ECR #: P1

Title: Correction to Figure 3.17

Spec Version: NLX 1.2

Figure 3.17: Chassis Back Panel I/O Shield Opening

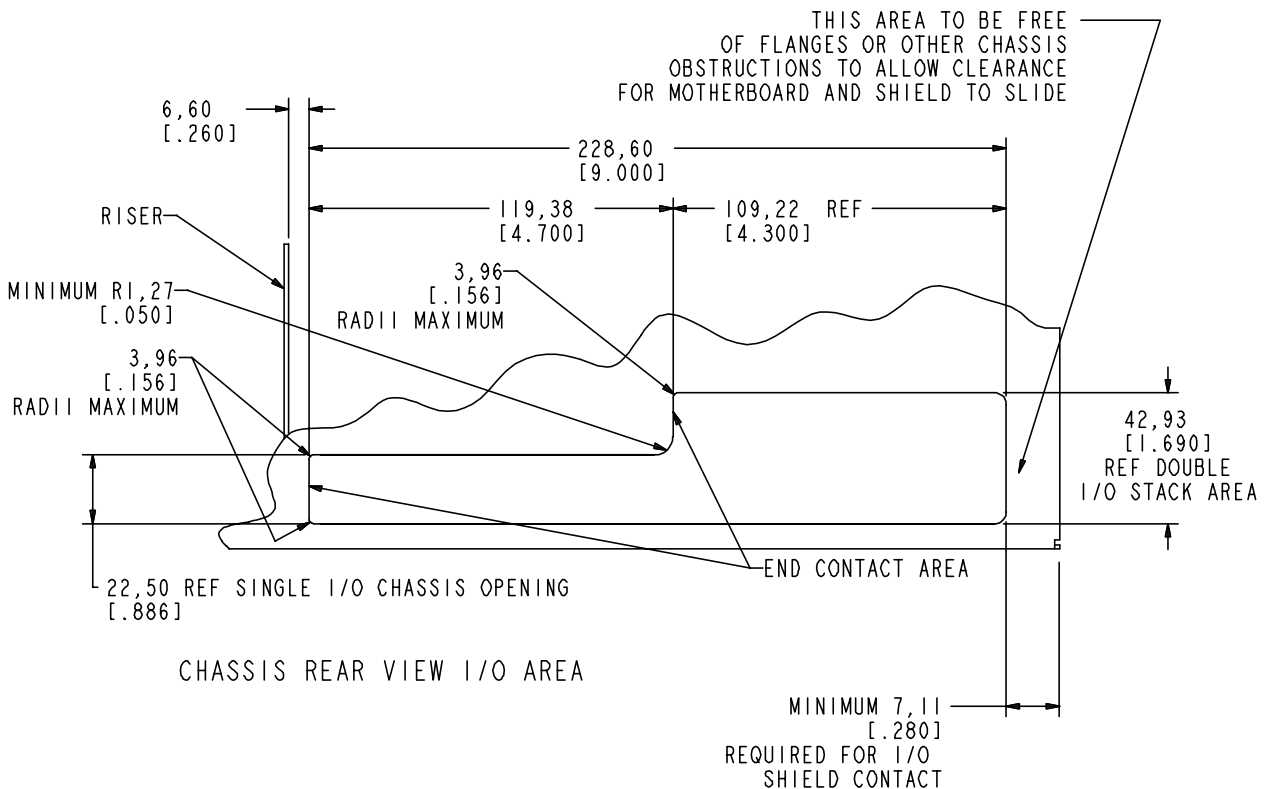
Change Figure 3.17 to correct the drawing.

The figure as shown in version 1.2 of the specification has incorrect corners for the I/O aperture. If a chassis vendor were to develop a chassis to this diagram, it would introduce unnecessary complications.

Replace Figure 3.17 with the following diagram.
